FOREST LAKES FILING NO. 7

COUNTY OF EL PASO, STATE OF COLORADO

CONSTRUCTION PLANS

MAY 2021

MAIN 'A' 48" RCP FOREBAY & BAFFLE STRUCTURE - PLAN VIEW
SCALE 1" = 5'

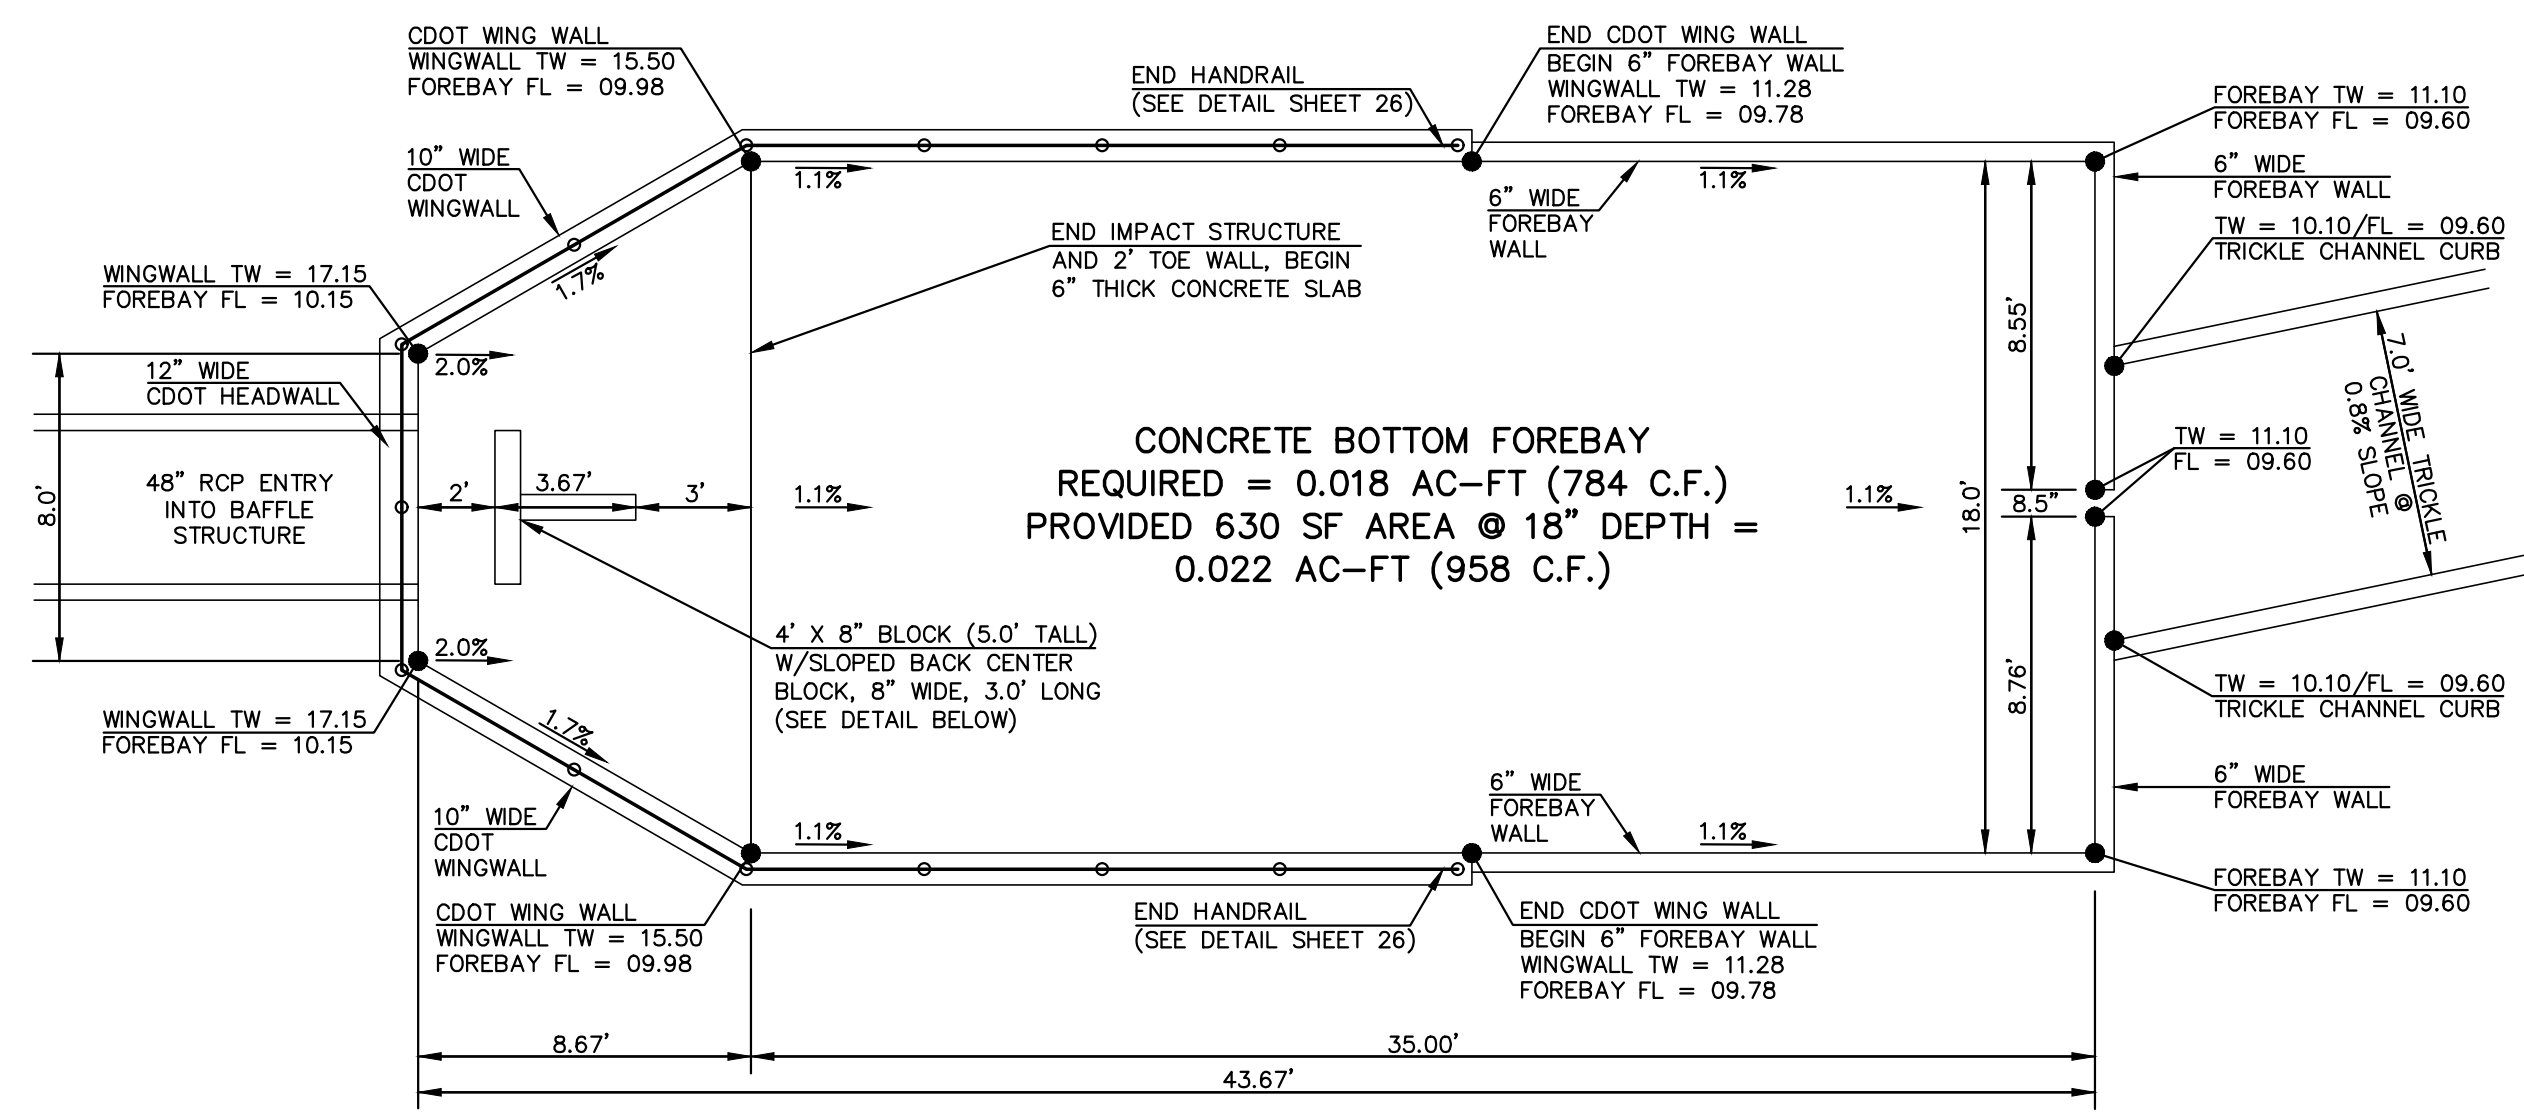
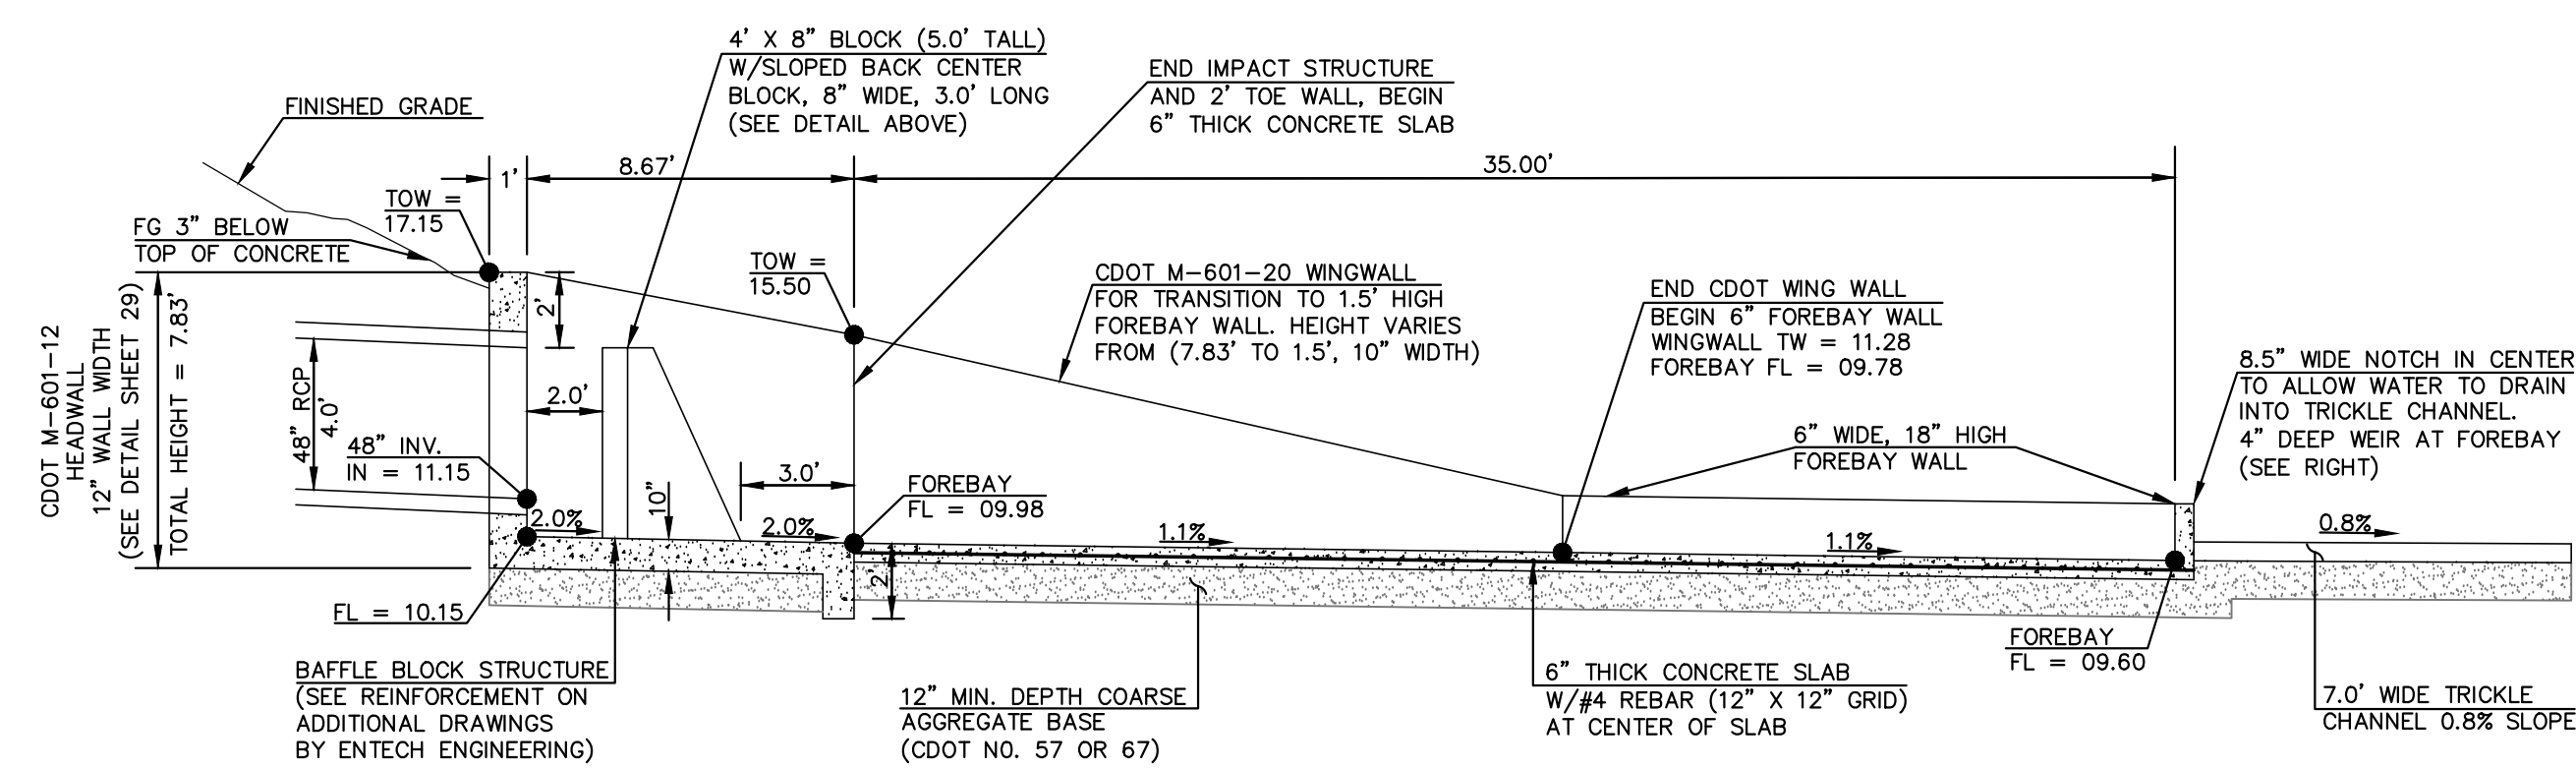
48" pipe with velocity greater than 18 fps requires type VI stilling basin per MHFD criteria. If the outlet velocity can be reduced to the 18 fps the current design can be utilized.
